Report: REVIVE REPORT
Function: Test, Adjust, & Balance
Date: 03/10/2023

**02-20-23 FREDDY'S - MCDONOUGH, GA
(REVIVE)**

Purpose of the visit to Freddy's in McDonough GA was to address complaints of hood capture issues.

Issue Name : 05 - ACSPS is dirty

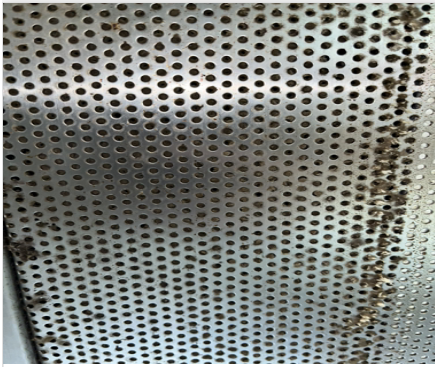
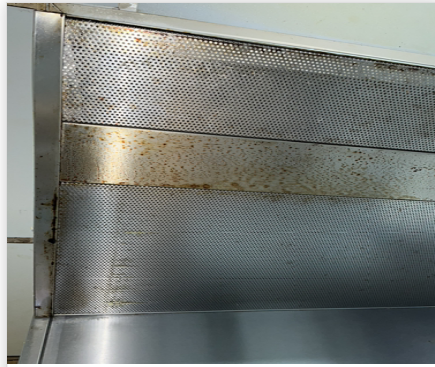
Description : Recommend dropping the AC-ssp portion and cleaning the top and bottom of the perforated grilles.
